Monticello Nuclear Generating Plant
2807 W County Rd 75
Monticello, MN 55362

L-MT-12-091
10 CFR 50.90

Monticello Nuclear Generating Plant
Docket 50-263
Renewed License No. DPR-22

Monticello Extended Power Uprate: Supplement to Revise Technical Specification
Setpoint for the Automatic Depressurization System Bypass Timer (TAC MD9990)

Figure 1 -RWCU Break Scenario PCT Results

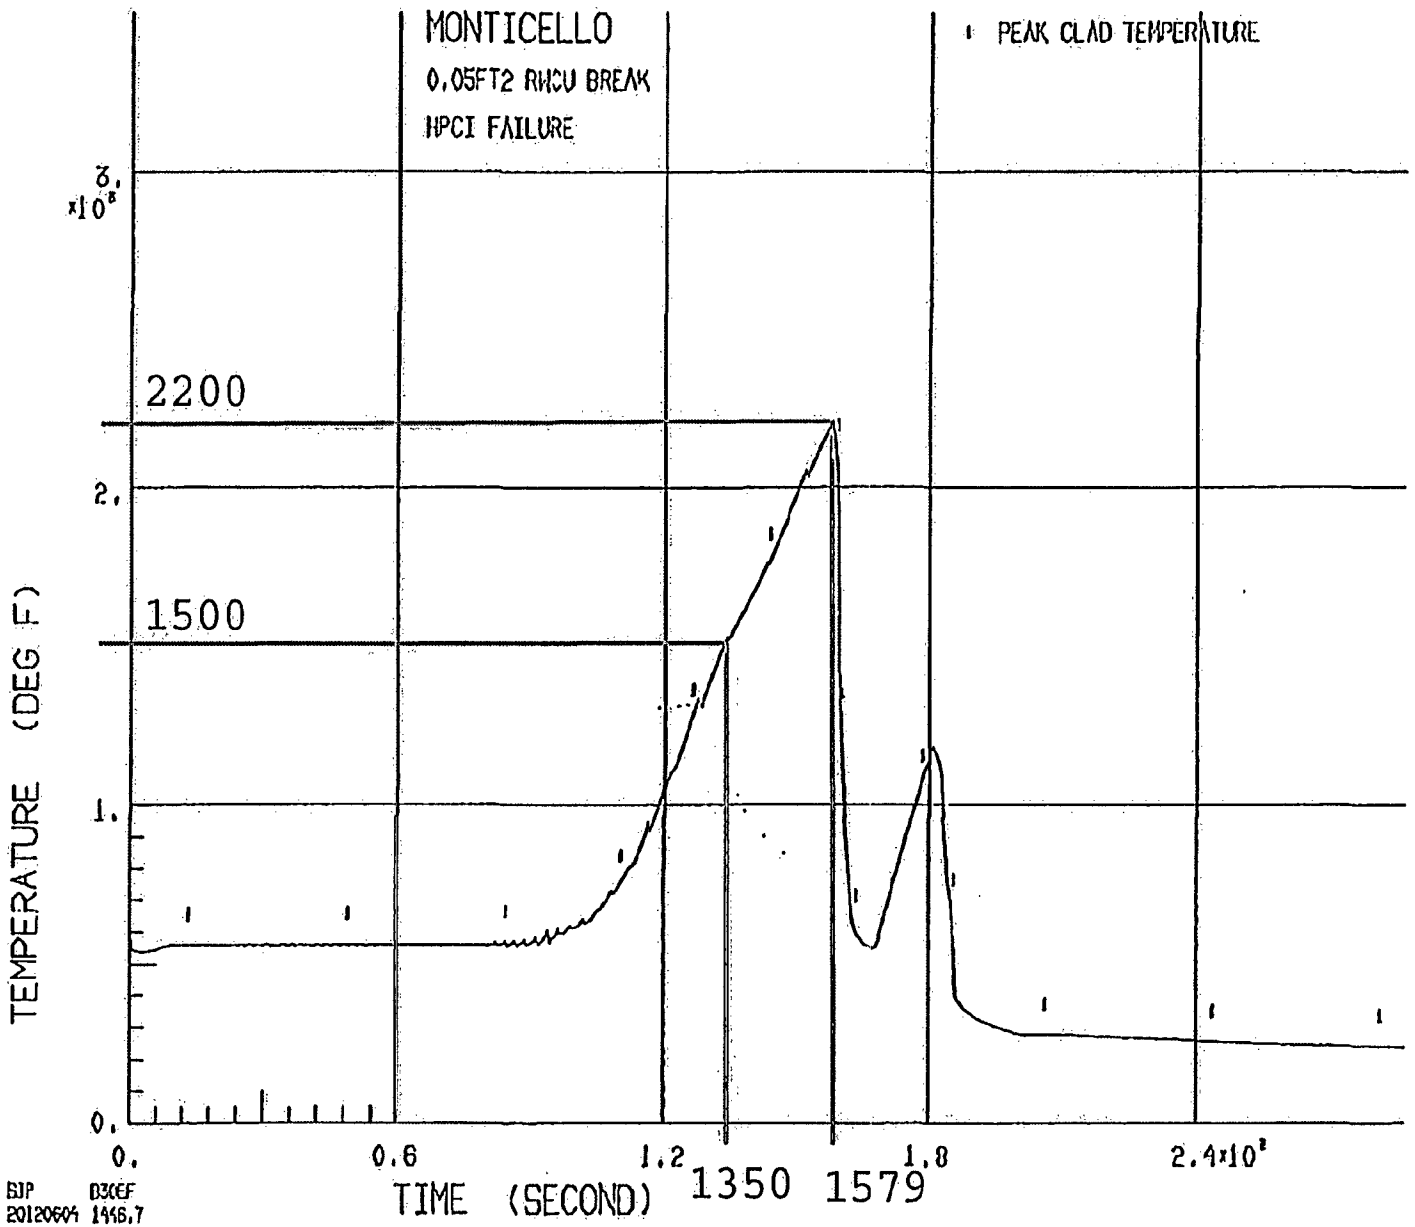
From above, it was determined that the bounding scenario (a RWCU break under MELLLA+ conditions using a gate valve closing profile) yielded a time of 1579 seconds (26.3 minutes) to reach 2200°F. From data provided with the above calculation it is also shown that it takes approximately 1350 seconds (22.5 minutes) to reach 1500°F (See Figure 1). In order to provide additional conservatism in the time to cool the core, it was decided that the actuation of ADS should occur prior to reaching 1500°F. Thus 22.5 minutes becomes the bounding limit for the scenario based on not exceeding 1500°F.

Removing these delays from the 1350 seconds limit yielded 1158 seconds (19.3 minutes). This value became the Analytical Limit used for calculation of the ADS bypass timer setting.

Based on these results, NSPM has established a proposed trip setting (TS limit) of ≤ 18 minutes for the ADS bypass timer setpoint. This will ensure peak cladding temperature (PCT) remains well below the 10 CFR 50.46 limit for PCT of 2200°F during EPU and MELLLA+ operating conditions.
